# UNITED STATES PATENT AND TRADEMARK OFFICE

10/579,735

<b>Office Action Summary</b>	<b>Application No.</b> 10/579,735	<b>Applicant(s)</b> SON ET AL.	
	<b>Examiner</b> ROBERT SCRUGGS	<b>Art Unit</b> 3723

### DETAILED ACTION

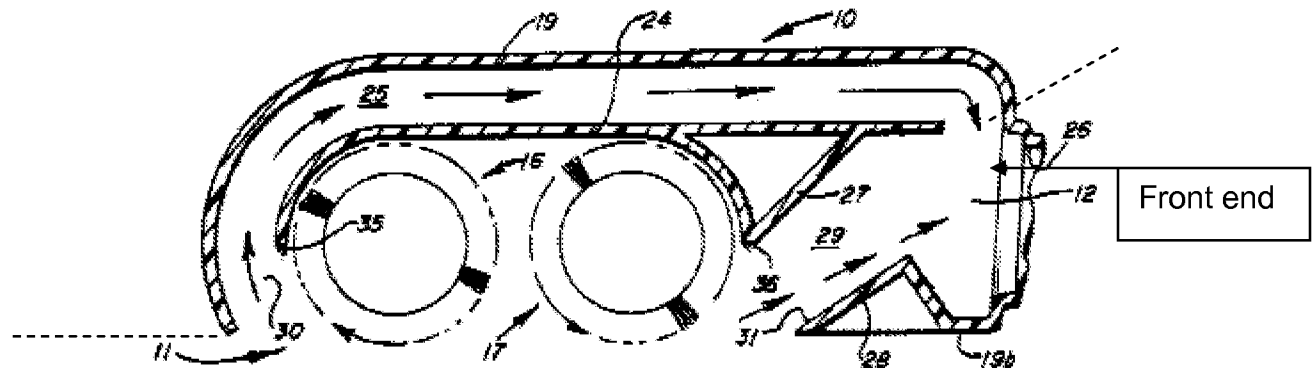
In reference to claim 1, Nordeen discloses a vacuum cleaner comprising: a suction head (10) installed at a front end of a suction path (12) that sucks substances by a vacuum pressure generated by a suction motor (not shown) and having a suction hole (11) on a bottom of the suction head through which the substances are sucked in to the suction path, a brush (17) rotatably installed in the suction hole of the suction head and

rotated to contact a surface and at least one hair tunnel (25) formed on the suction head such that the at least one hair tunnel and the brush do not interfere with each other, wherein the at least one hair tunnel preferentially sucks thin and long substances from the surface, but lacks, a sweeper provided at an inlet of the at least one hair tunnel that preferentially sucks the thin and long substances from the surface into the at least one hair tunnel. However, Waldhauser teaches a technique of including a sweeper (36 or 38) installed at the inlet unit of a hair tunnel formed by elements (46 and 29, see figure 6) for preferentially sucking the thin and long substances from the bottom to the hair tunnel. It would have been obvious to one of ordinary skill in the art to modify the cleaning device, of Nordeen, with the known technique of using a sweeper assembly at an inlet portion of a tunnel, as taught by Waldhauser, and the results would have been predictable. In this situation, one could provide a vacuum that more effectively removes dirty water from the surface being cleaned.

In reference to claim 2, Nordeen also shows that the hair tunnel is linked to the front end of the suction path through a path isolated from the path (29) for linking the suction hole to the front end of the suction path in the suction head (see figure below).

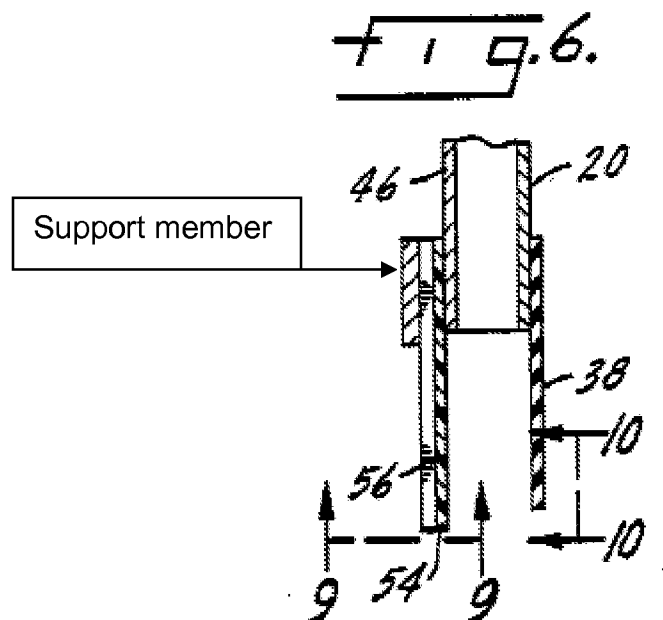
In reference to claim 6, Waldhauser also teaches that a sweeper can comprise a first sweeper (36) partially downwardly protruded from the bottom surface of the end of the inlet unit of the hair tunnel far from the suction hole and a second sweeper (44) downwardly protruded from the bottom surface of the end of the inlet unit of the hair tunnel close to the suction hole.

In reference to claim 8, Waldhauser also shows that the first and second sweepers are formed in a comb-tooth shape (Figures 9 and 10).
